MetroWest Engineering, Inc.

RE: Notice of Intent for 8 View Avenue, Sovereign Builders, Inc.  
MADEP File Number 246-0785

**Review of Stormwater Management System for View Avenue Condominium Project, Northampton, MA**

Soil Map—Hampshire County, Massachusetts, Central Part

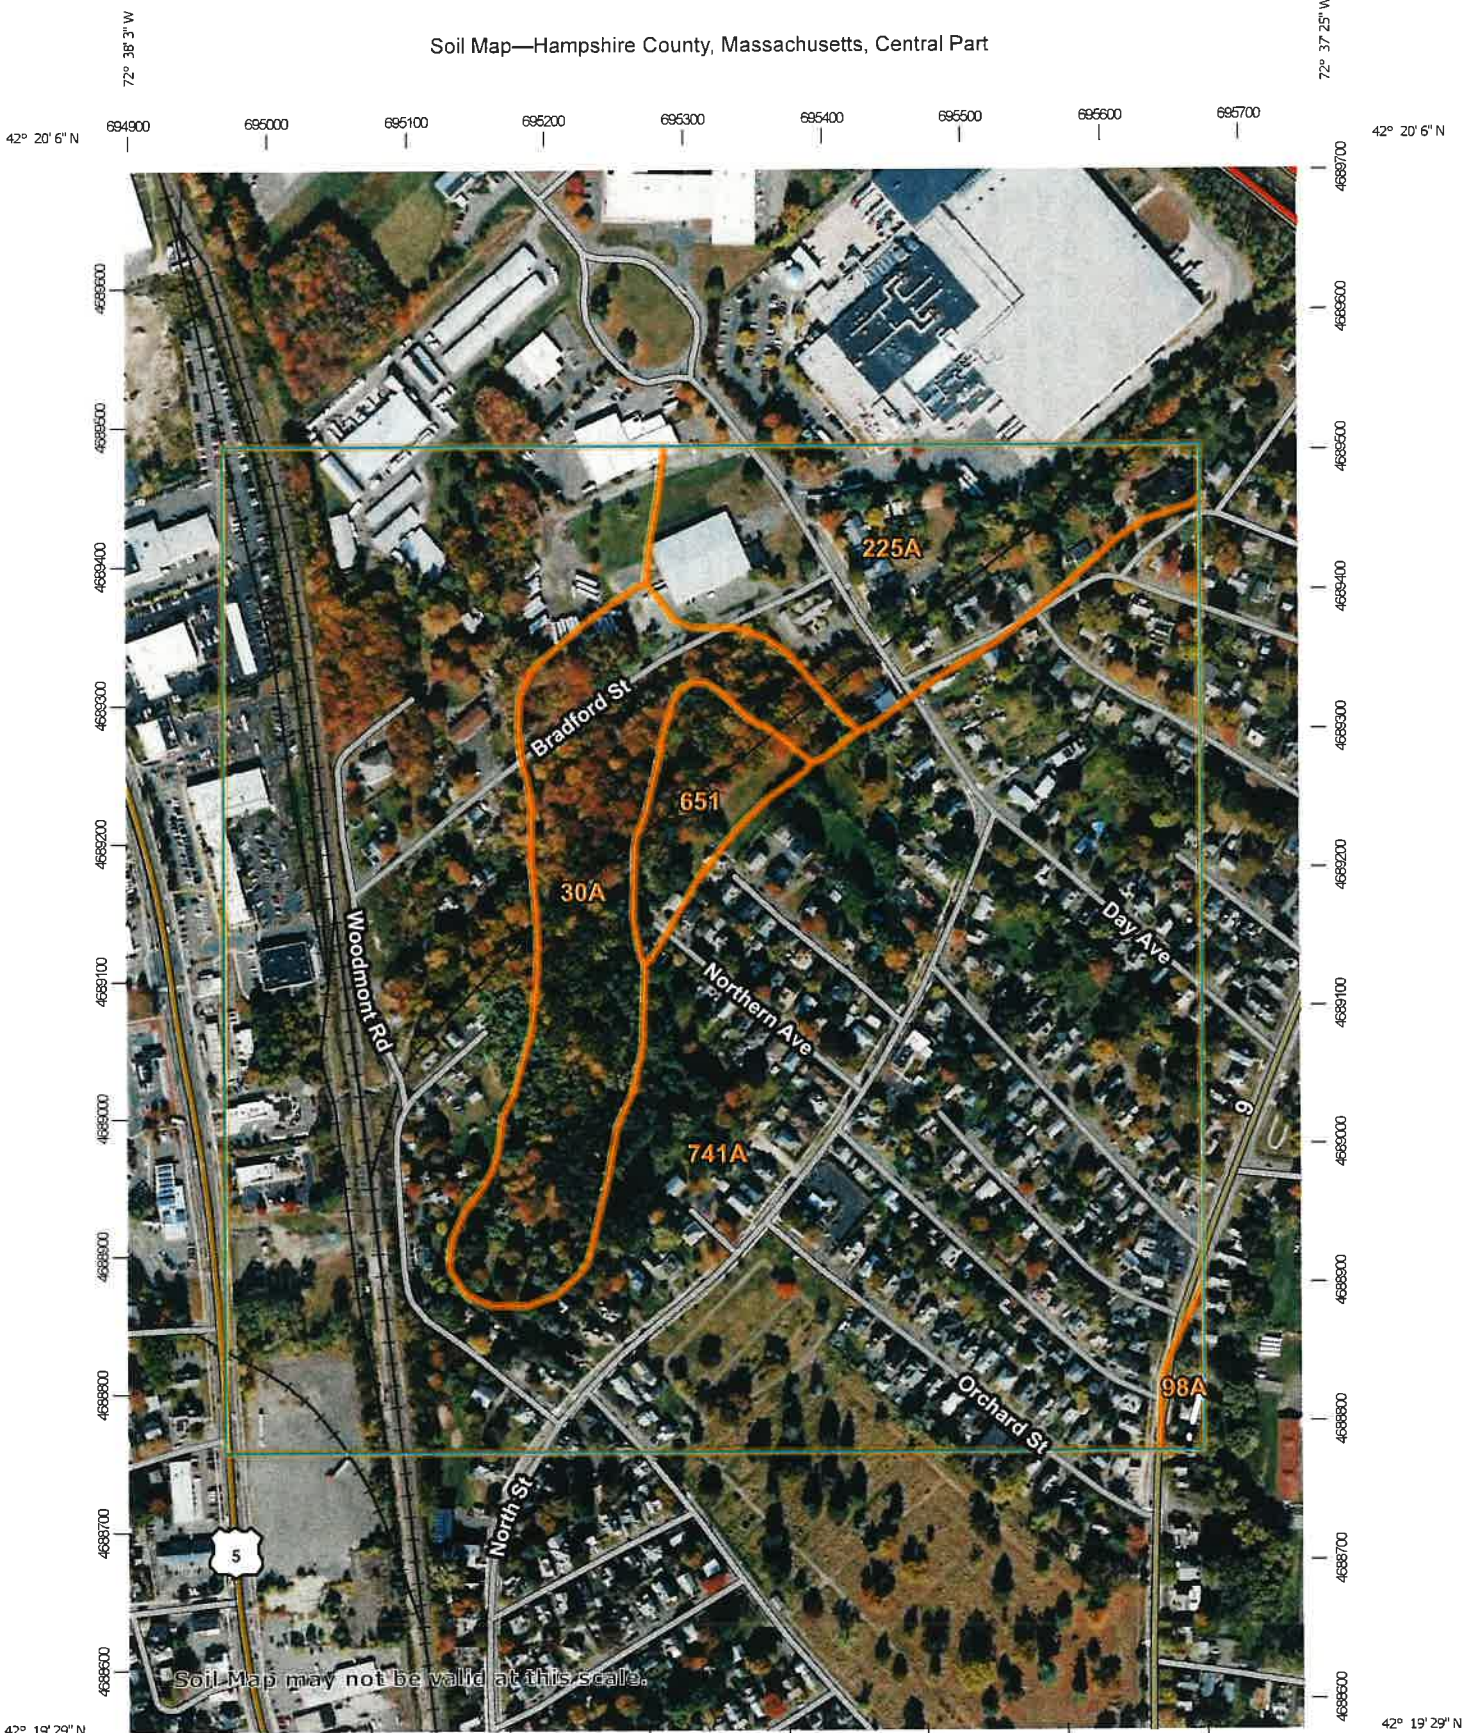
Hydrologic modeling of the pre- and post-development conditions of the site requires a Curve Number Selection for site conditions based on surface land use and the underlying soil types as mapped by the NCRS. The NCRS mapping for site shows two major soil series. The rear or northerly portion of the site, roughly following the wetland resource, consists of soils within the Raynham Silt Loam Series. The USDA classifies these soils as Hydrologic Group C/D, with the more poorly drained soils, the D soils, likely within the wetland, and the better draining C soils upland of the wetland border.

The soils in the southerly portion of the site, the area of the site designated for development, lie within the Amostown-Windsor silty stratum-Urban land complex Series. These soils are classified as Hydrologic Group A and B soils, indicative of lower stormwater runoff than Hydrologic Group D soils. While it is true that both the Raynham and the Amostown/Windsor soils exhibit seasonally high groundwater levels, the Amostown/Windsor series produce much less stormwater runoff due to water retention in the upper soil horizons. I have provided the USDA NCRS description for the relevant soil series present on this site

The watershed delineation plans should identify the USDA NCRS soil boundaries on the plan, so that runoff curve numbers used in the hydrologic model may be accurately defined. This basic step in preparing a reliable hydrologic model has not been done, and it renders the results of the model as suspect.

The submitted hydrologic analysis assumes that all soils on the site lie within the Hydrologic Group D classification, an assumption that is in direct conflict with the published soil series. The result of this error is that the hydrologic model, for the pre-development condition, produces
